Rezoning Transportation Analysis

Petition Number: 2021-114

Date	Description
09-15-21	First Review (BKB)

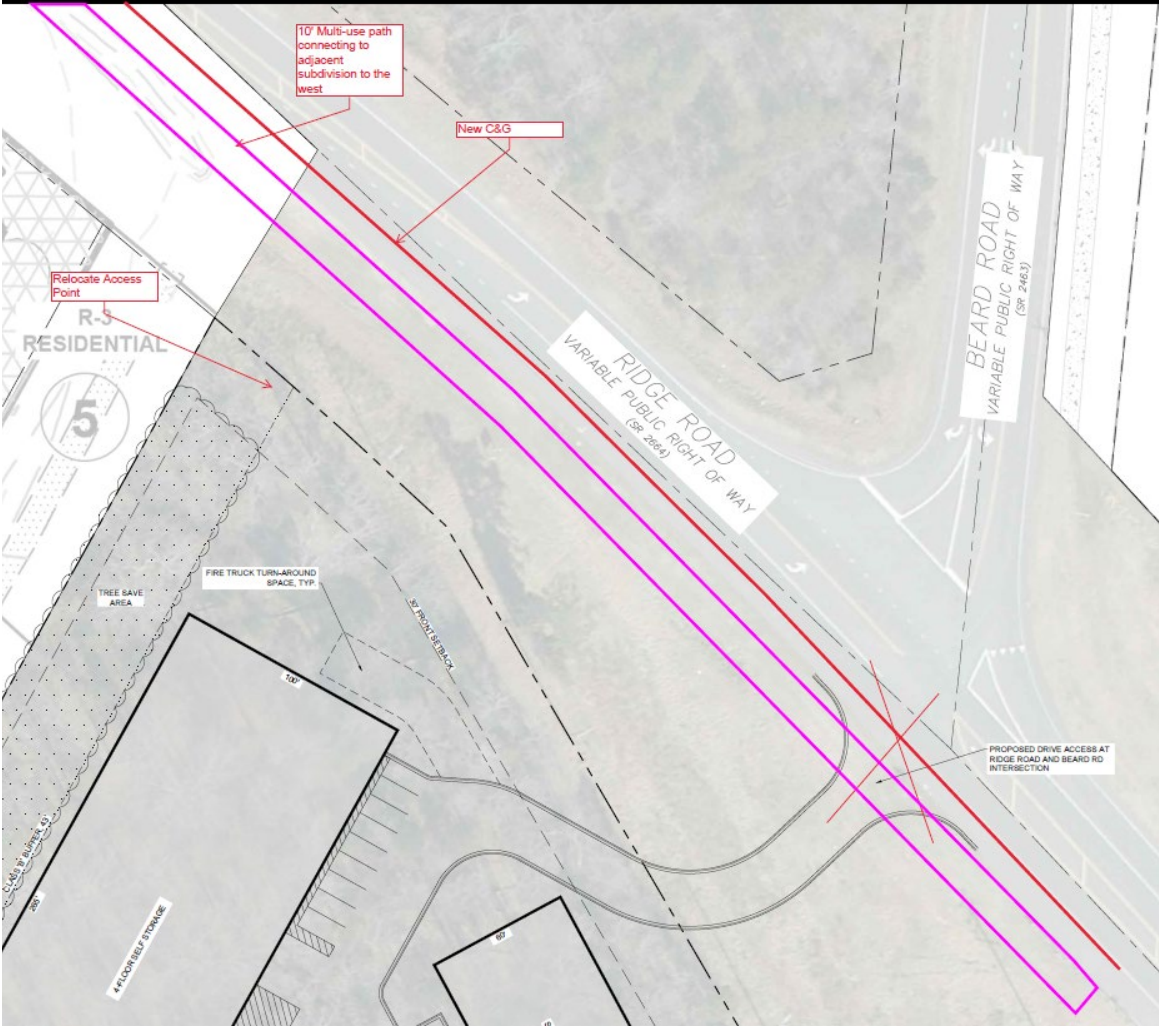
1. **Curblines:** The proposed zoning district has a setback measured from back of the existing or proposed future curblines.
 - a. **Ridge Road:** Provide curb and gutter along existing edge of travel lane along the entire property frontage. Use existing edge line for placement of gutter.

Label and dimension the curb and gutter from the centerline for Ridge Road on the site plan.

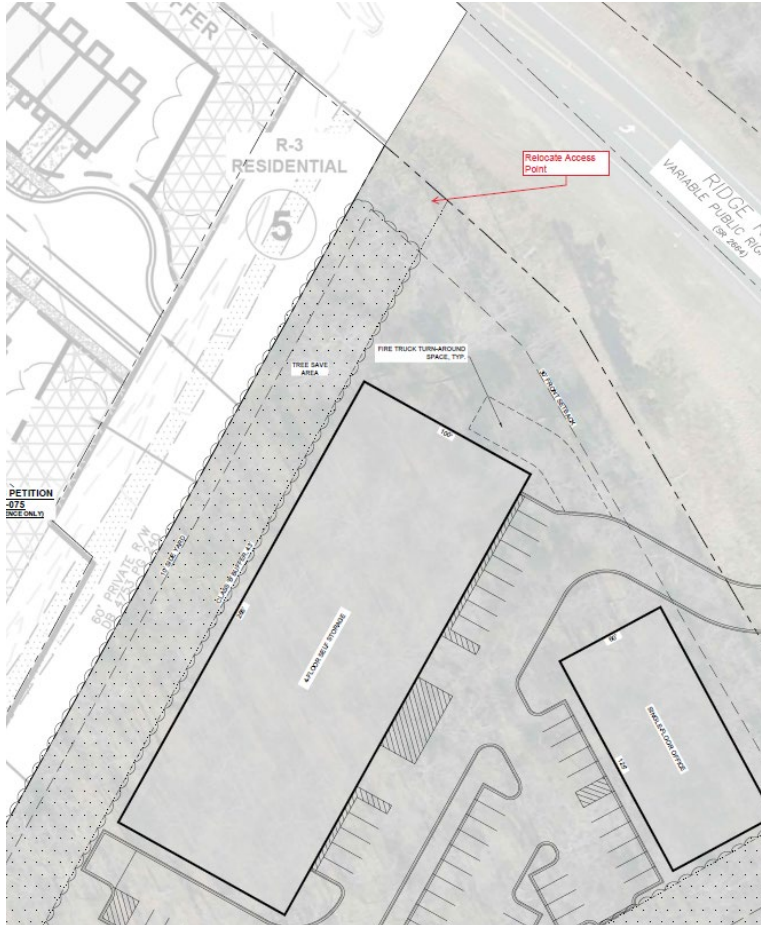
4. Site plan and revisions are needed to reflect the access point to the development on the western portion of the property per the below image. The existing Ridge Road and Beard Road intersection would require improvements that aren't commensurate with the development, so this relocated driveway will require less improvements of the developer within Ridge Road.
